## DIXON MEADOWS JSP14-46 with Rezoning 18.709

Public hearing at the request of Pulte Homes for Planning Commission's Recommendation to City Council for a Planned Rezoning Overlay associated with a Zoning Map amendment, from RA (Residential Acreage) to RT (Two-Family Residential). The subject property is approximately 22.36-acre and is located in Section 10 on the east side of Dixon Road, north of Twelve Mile Road. The applicant is proposing a development of a 90-unit single-family residential detached site condominium. An alternate plan is being presented for public hearing, review and recommendation.

Review based on 4<sup>th</sup> Revised Concept Site Plan on February 16, 2016

**Before**

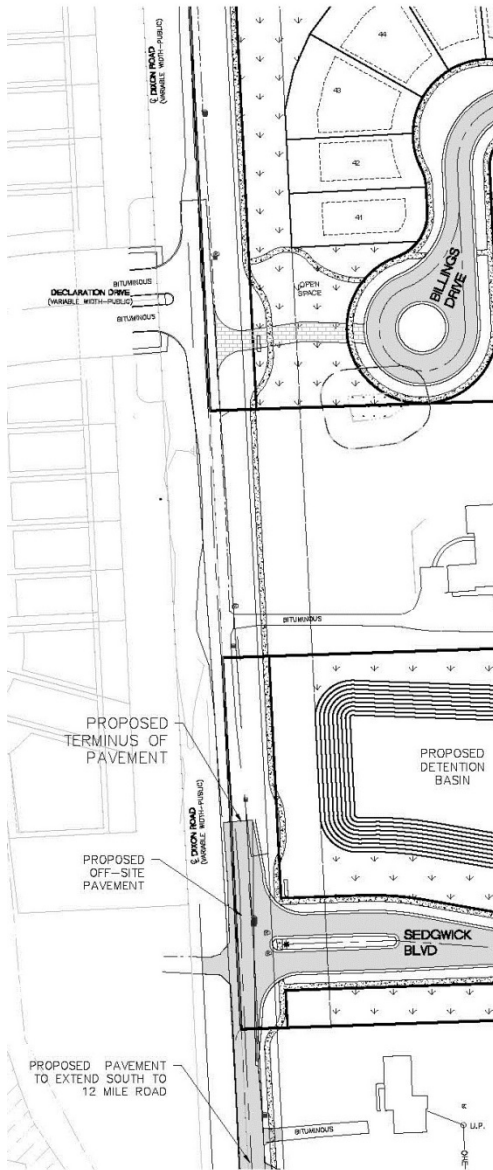
particular, we have incorporated an alternating double row of oversized 12' evergreen trees behind the Liberty Park homes that back up to Dixon Road adjacent to the proposed Dixon Meadows development. The following images provide a realistic idea of what this landscape treatment will look like from Dixon Road after being installed:

OPTION 1:  
PAVING DIXON ROAD FROM SEDGWICK BLVD TO 12 MILE ROAD

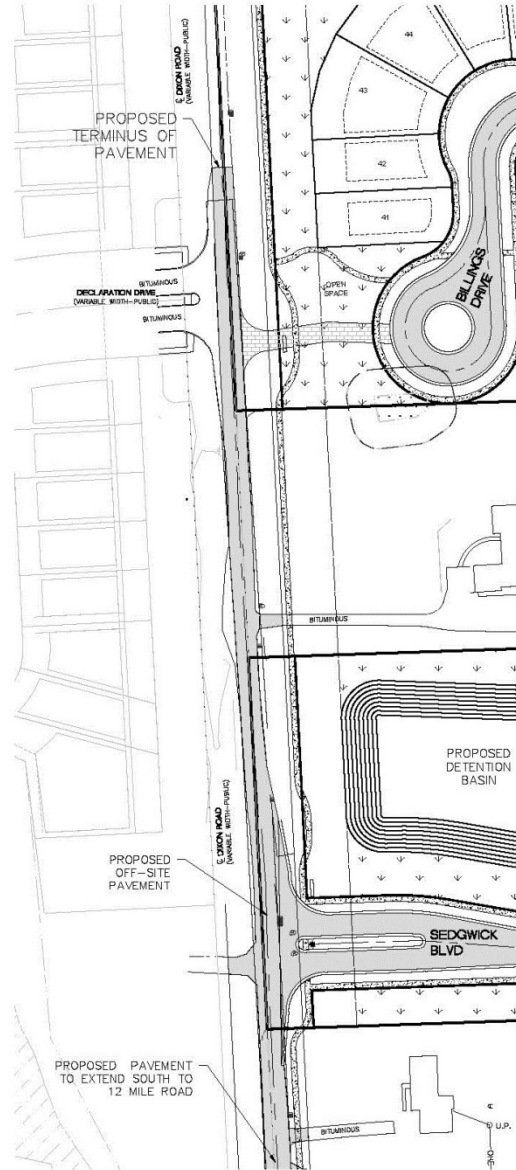
Currently Pulte is proposing to pave Dixon Road from the 12 Mile Road terminus pavement point, to the Liberty Park Boulevard entrance at Declaration Drive. The residents expressed their desire to terminate the paving of Dixon Road at the entrance to Dixon Meadows. The two options are shown as follows:

Pulte is willing to construct either option and is looking to the City representatives to provide their formal input as to where to terminate the paving of Dixon Road.

Figure 1. City of Novi Regulated Wetland & Woodland Map (approximate property boundary shown in red). Regulated Woodland areas are shown in green and regulated Wetland areas are shown in blue).

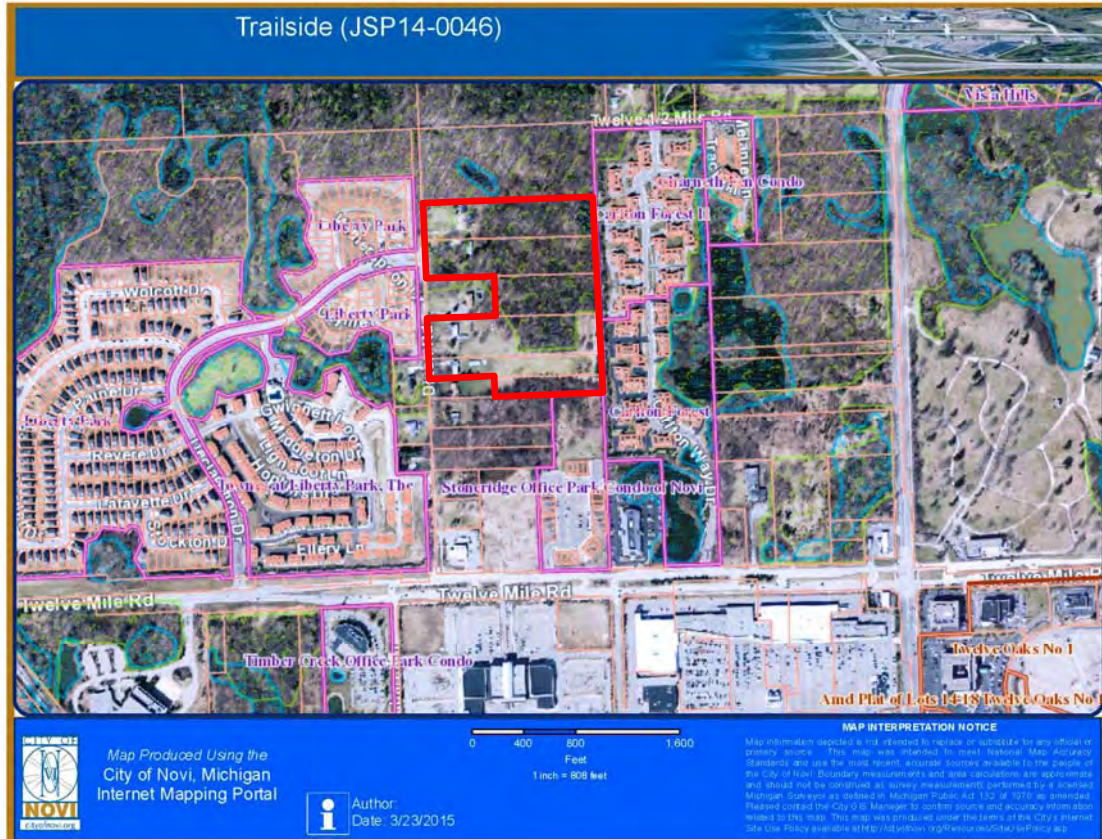
The proposed development is located north of Twelve Mile Road and east of Dixon Road in Section 10. The Plan proposes the construction of ninety (90) single-family residential site condominiums (reduced from 92 on the previous concept plan submittal), associated roads and utilities, and a storm water detention basin. Two home sites were removed from the Plan (previously units 67 & 68) and a pocket park has been provided along the eastern property boundary. Although not indicated on the City's Regulated Wetlands Map (see Figure 1), the proposed project site contains one area of City-Regulated Wetlands (see Figure 2). Some wetland areas are located to the north of the project property. A very small portion of 25-foot wetland buffer/setback extends onto the north side of the site from one of these wetlands (i.e., Wetland A).
